**Informal document N° 14**  
*(31<sup>st</sup> GRSP, 13-17 May 2002*  
*agenda item 1.8)*

**ECE REGULATION 95 – LATERAL IMPACT**  
**Proposal TRANS/WP29/GRSP/2002/11**

**OICA COMMENTS**

<b>SUBJECT : Concerns Regarding the Thoracic Response of the ES-2 Side Impact Dummy</b>
---

**Figure 1:** Variation of Deflection and VC for pendulum tests

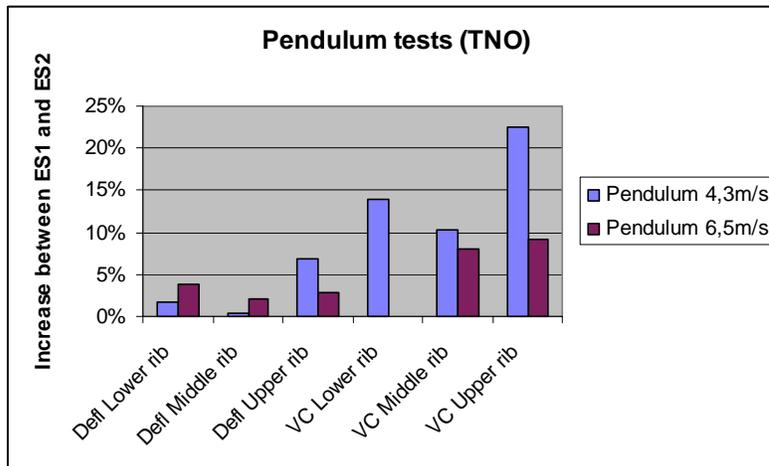
Authors of the report explain that ES2 has lower criteria than ES1 in biofidelity tests. However, pendulum tests show an increase of criteria between ES1 and ES2: between 0 and 7% for deflection and up to 22% for VC (Figure 1), especially for the upper rib.

**Figure 2:** Mean peak rib deflection for each impact angle (from TRL ES-2 Prototype Evaluation)

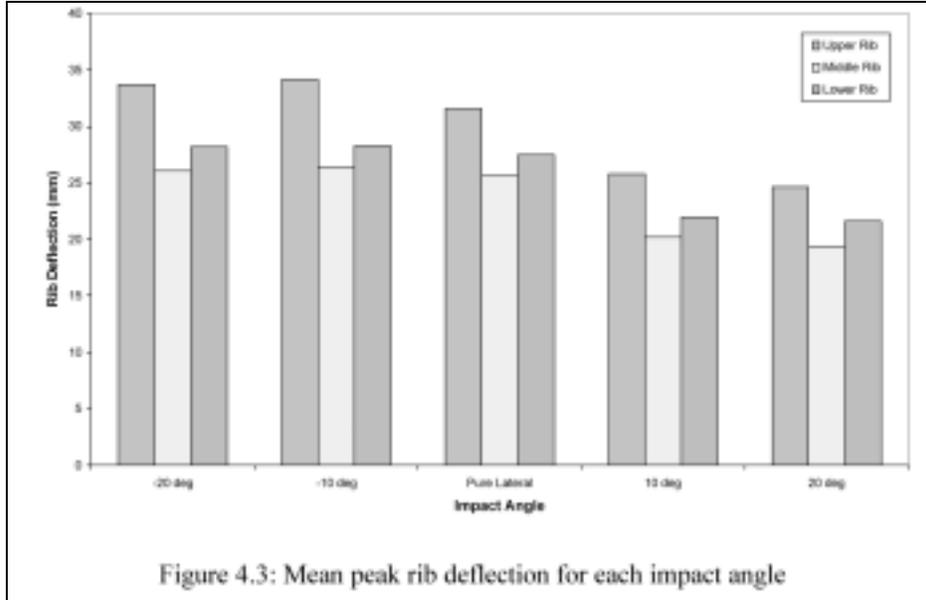
The study shows that when impacted at angles of +10° and +20° (forward of y-axis) the measured deflection is lower than at 0° (purely lateral). This is not surprising. However, at -10° and -20° the measured deflection is higher than at 0°! (Figure 2). The authors make the following comments:

The authors go on to add that the effect would be less apparent in Eurosid-1 than in ES-2 since the displacement transducer of the latter is mounted rearward of the piston. If this is true, the difference could be an increase in deflection for the ES-2 of 10%. The problem is that no data exist on ES-1 at  $-10^\circ$  and  $-20^\circ$ .

An illustration of this in-homogeneity is given by Figure 2 where the middle rib deflection is always lower than other ribs, while one should expect to have a continuous evolution from lower to upper rib, as with Eurosid0 [Friedel et al].

**Figure 3: ES-2 rib module**

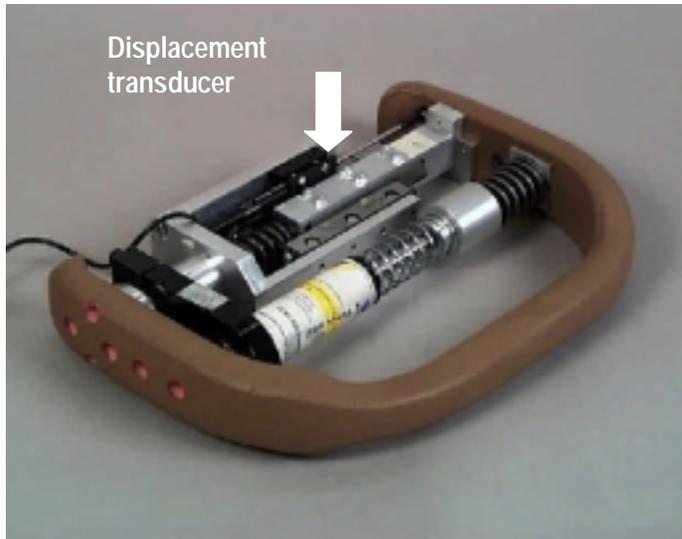
It seems likely that the change in position of the rib displacement point of measurement can have an effect on the measured values of the displacement when oblique loading components are present on the dummy. This may affect the results of regulatory and EuroNCAP full-scale testing.

**Figure 4: Force-deflection curves of Thorax for pendulum tests**

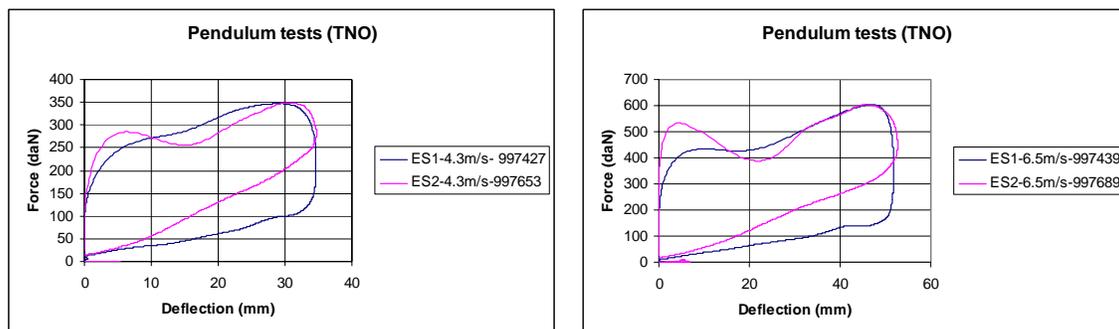
ES2 demonstrates less overall damping than ES1, as shown in Figure 4.

Overall damping is constituted by damper and friction or structural damping. Friction is eliminated in ES-2 and compensated by increasing the tuning spring.

**Figure 5:** Pendulum time history curves for pendulum tests

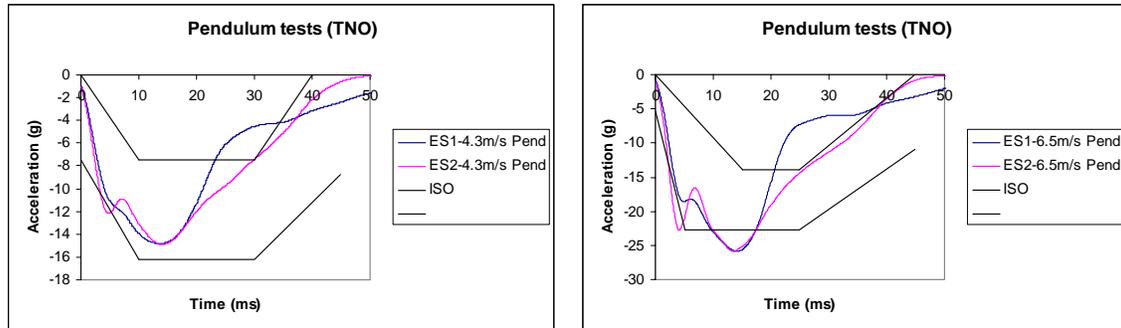
The unloading behaviour of ES-2 is, as expected by the rib module design, quite elastic. Indeed, the damper is ineffective in the unloading phase and only friction in ES1 allowed to have a more realistic unloading behaviour. The author explains that «*the stiffer tuning spring even resulted in a more biofidelic rebound*». We do not agree with this statement: only being in the corridor doesn't mean to be biofidelic. In fact, the unloading corridor should not be reached thank to a smaller hysteresis, which is not realistic, but by a smaller thorax stiffness which will increase the overall period. ES2 makes the contrary: the stiffness is increased (Figure 5) and hysteresis is decreased, which leads to increase the period of force-time history.

**Figure 6:** Lower rib deflection time histories (Renault Mégane full-scale tests)

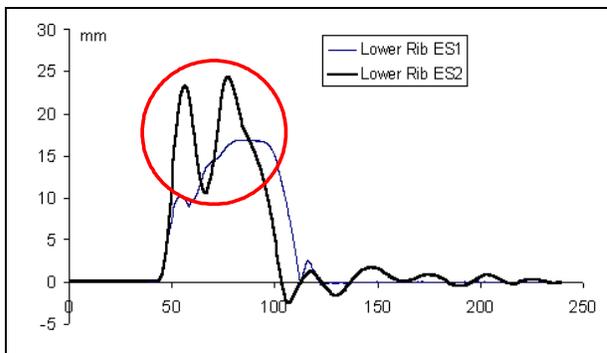
The observed frequency (Figure 6) in the Renault Megane full-scale test (as well as other full-scale tests like VW Lupo and Audi) is a consequence of elastic rebound of the thorax, governed by the natural frequency of the rib module (which is higher than 26Hz during unloading phase, seeing that the stiffness of the rib itself was missed in the calculation). The author explains that «*the elimination of the friction in the guide system makes the ES-2 thorax more discriminating against different types of loading*». That is true, but the question is then to know if the human body is so discriminating.

This way of decreasing friction in rib modules doesn't seem appropriate and should be investigated more in depth.

**Figure 7:** Pelvis wall force in Heidelberg tests (from Annex B of EEVC report on Development and Evaluation of the ES-2 Dummy)

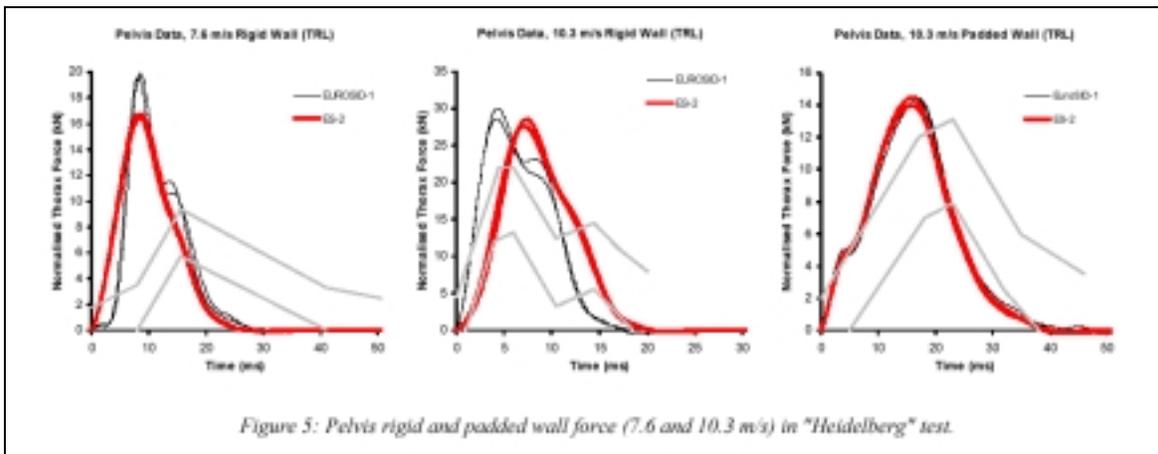
Figure 7 illustrates the evolution of pelvis loading between ES1 and ES2 where a delay in pelvis loading (max delayed about 5ms) can be observed on rigid wall. (a time-shift appears at 7,6m/s, which would have to be explained, but anyway, pelvis stiffness is lower for ES-2).

The effect of pelvis behaviour changing on thorax loading has to be investigated and biomechanical reasons have to be given before changing this point in regulation.

**Figure 8:** Pubic Symphysis sensitivity to angle (from Annex D of EEVC report on Development and Evaluation of the ES-2 Dummy)

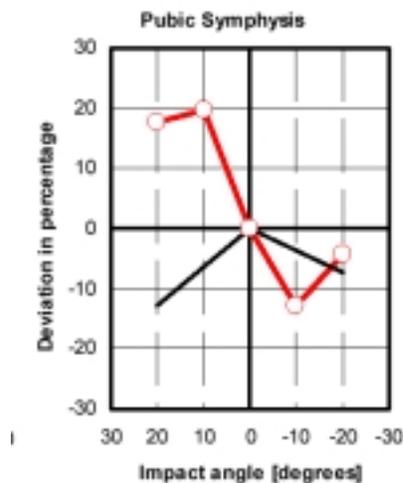
An additional concern on the pelvis is the difference between ES1 and ES2 for pelvis sensitivity to angle (Figure 8). The cumulative effect at 20° is 30%. As above, investigations and explanations have to be given.
